AMENDMENT UNDER 37 C.F.R. § 1.111
U.S. APPLICATION NO.: 09/855,652

AMENDMENTS TO THE DRAWINGS

FIG. 3

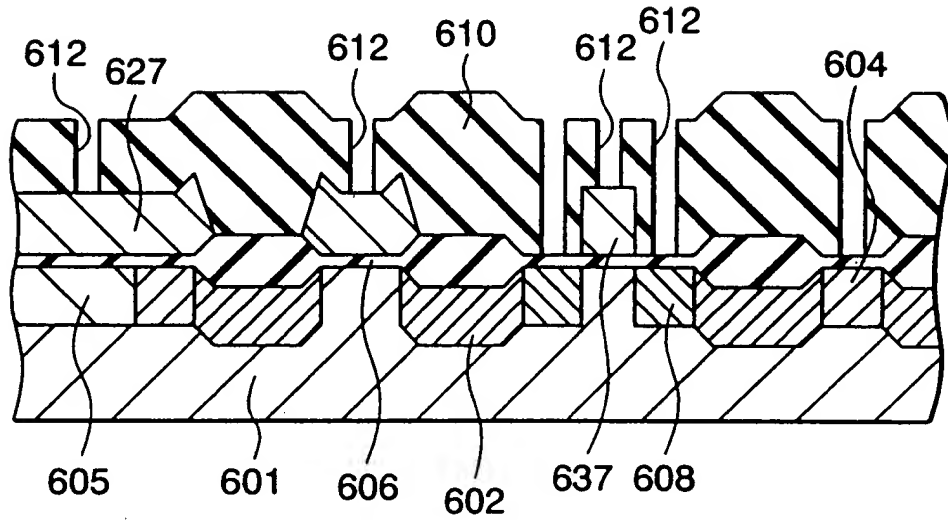
A replacement sheet for Fig. 3 is submitted herewith incorporating the proposed drawing correction that was approved by the Examiner in paper #8. Fig. 3 has been modified to show a constant voltage being applied to the isolating electrode.
